Errata

This errata sheet is for MB91270 Series Hardware Manual Rev.2 (CM71-10128-2E)

FR60Lite
 32-BIT MICROCONTROLLER
 MB91270 Series
 HARDWARE MANUAL

Addendum, MB91270 Hardware Manual (CM71-10128-2E)

Graphic 1:

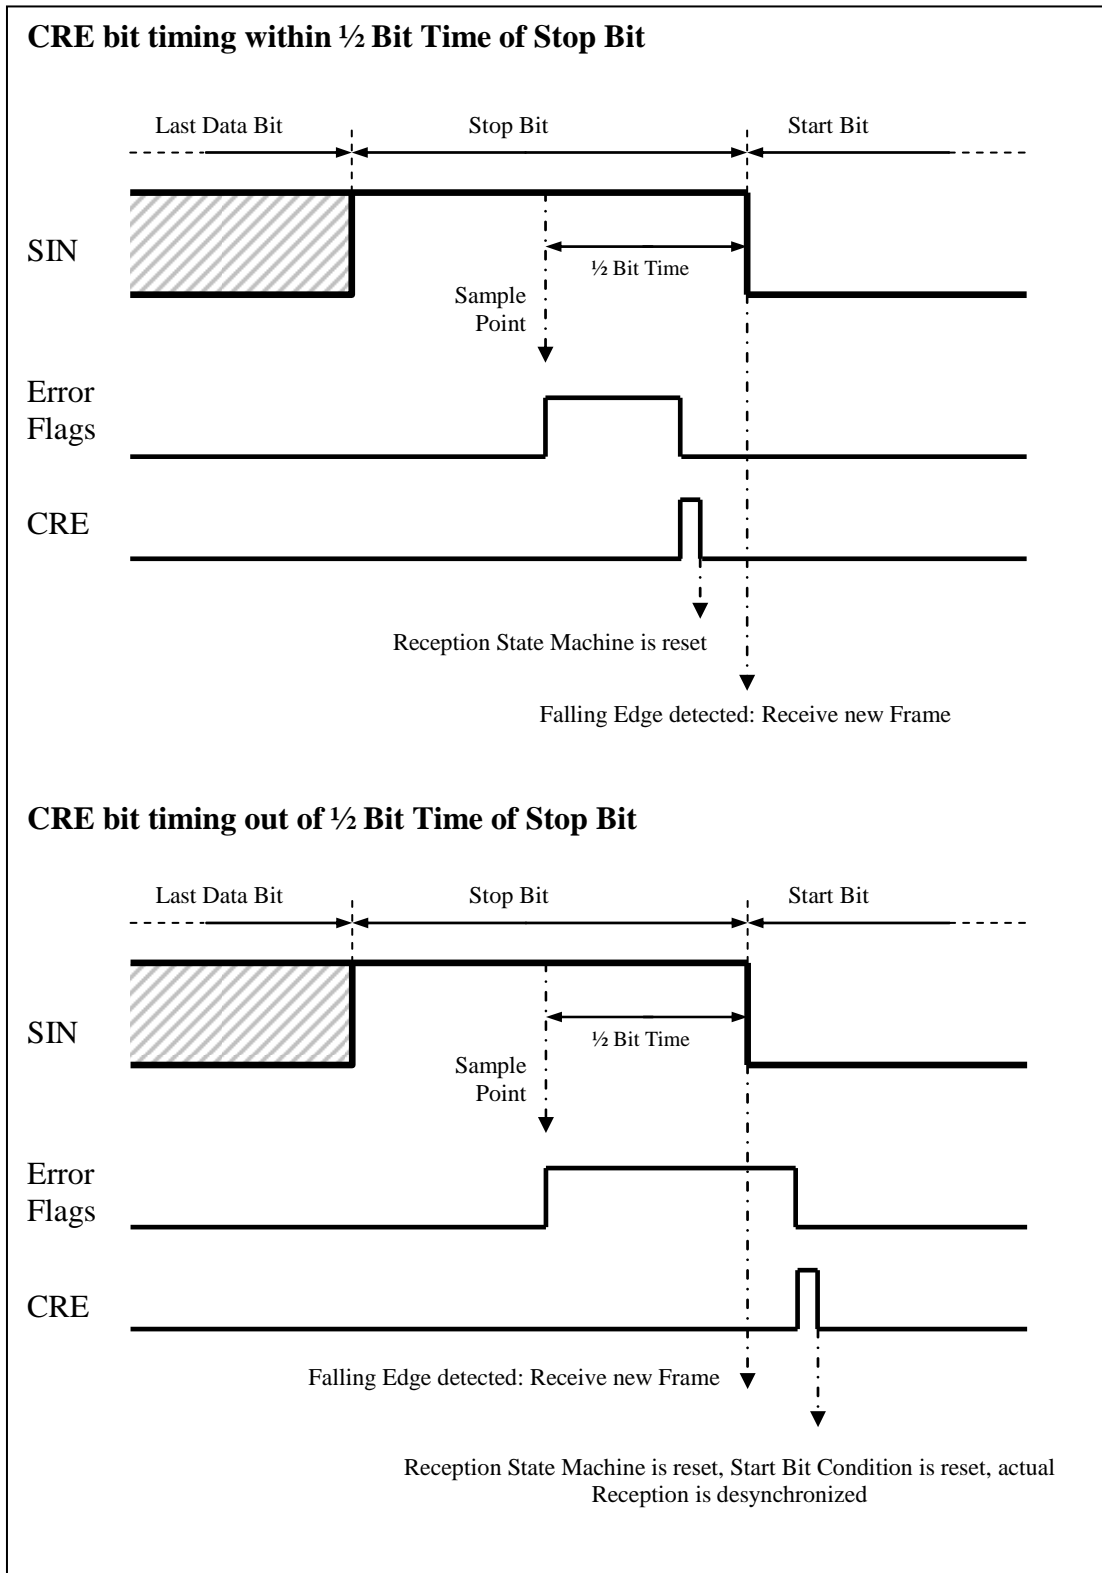
- 1) (Graphic 1) CRE resets reception state machine and next falling edge at SINn starts reception of new byte (graphic 1).

Graphic 2:

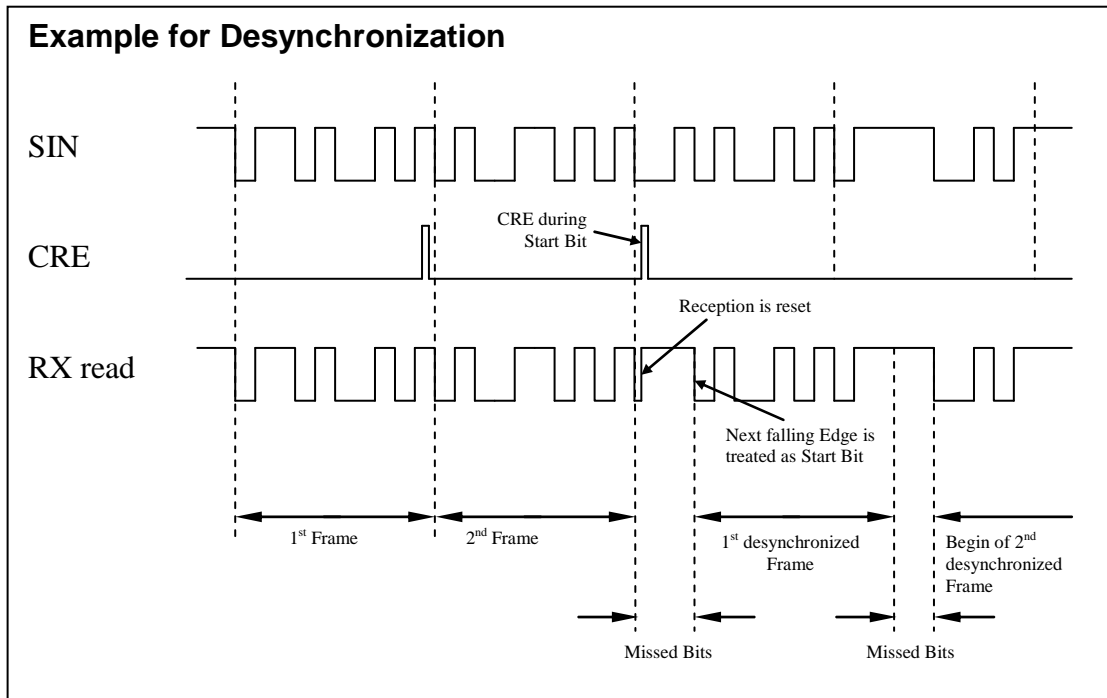
Therefore either set CRE bit immediately (within half bit time) after receiving errors to prevent data stream desynchronization (Graphic 2) or wait an application dependent time after receiving errors and set CRE, when SINn is idle.

Graphic 3:

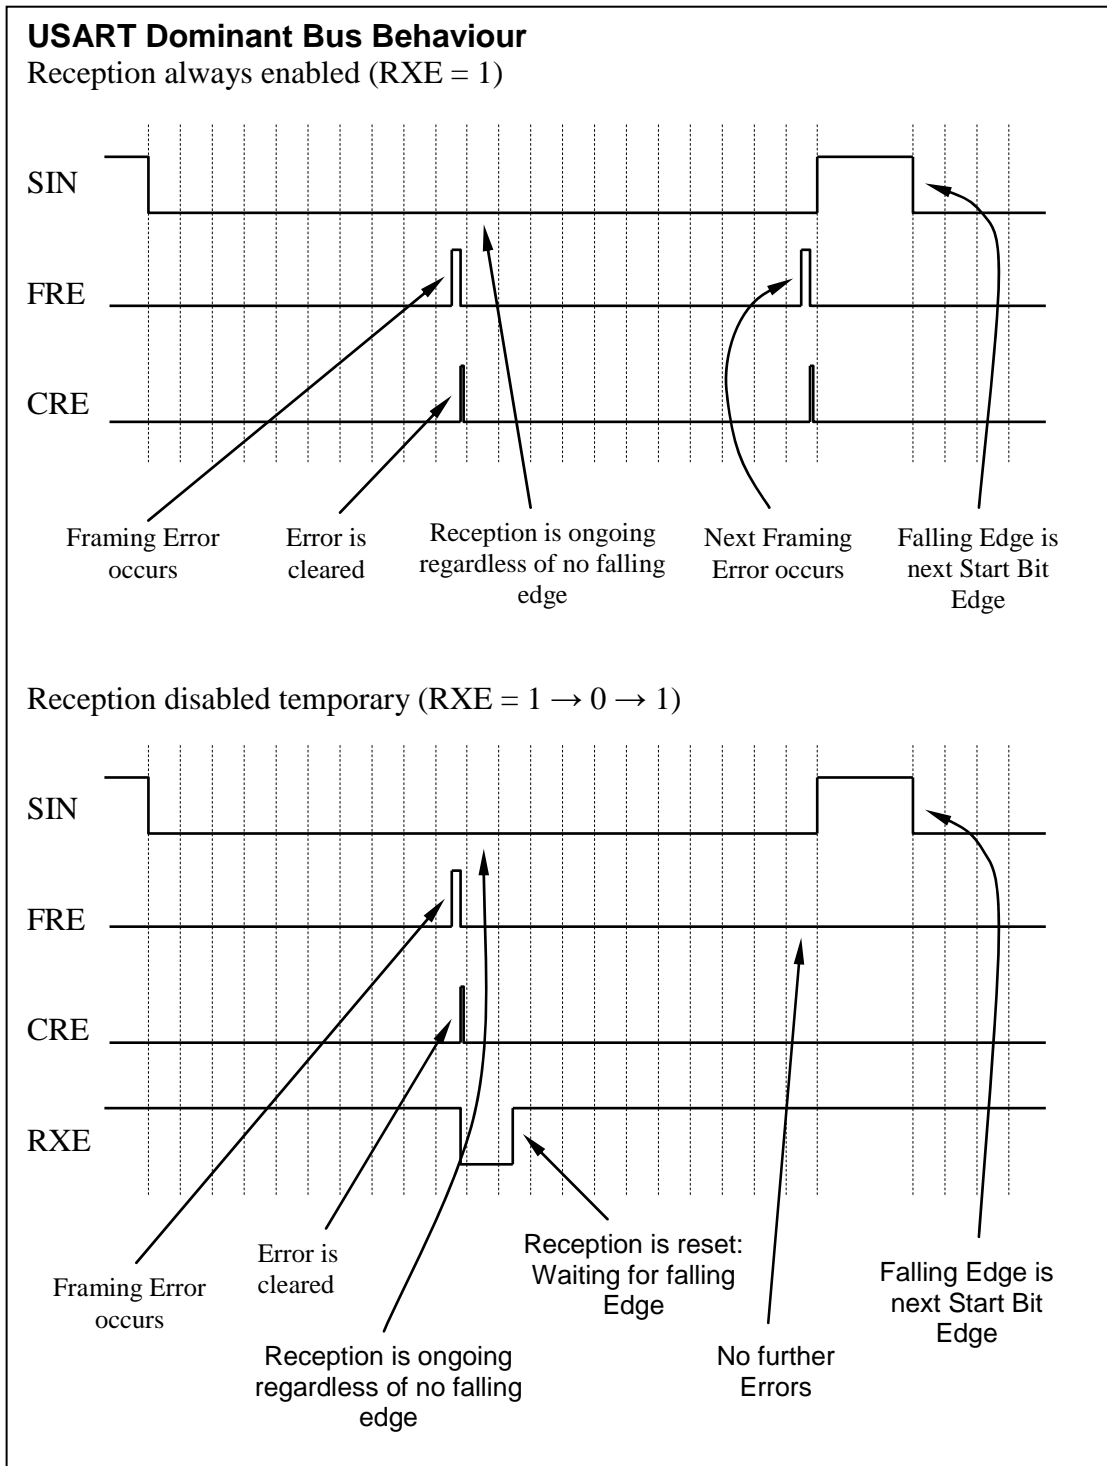
- 2) Please note, that in case a framing error occurred (stop bit: SINn = "0") and next start bit (SINn = "0") follows immediately, this start bit is recognized regardless of no falling edge before (Graphic 3). This is used to remain UART synchronized to the data stream and to detect that serial data input (SINn) keeps "L" level (Graphic 3 above) by producing next framing errors. If this behavior is not wanted, please disable the reception temporarily RXE = 1 -> 0 -> 1 after framing error. In this case, reception goes on at next falling edge on SINn. (Graphic 3 below).
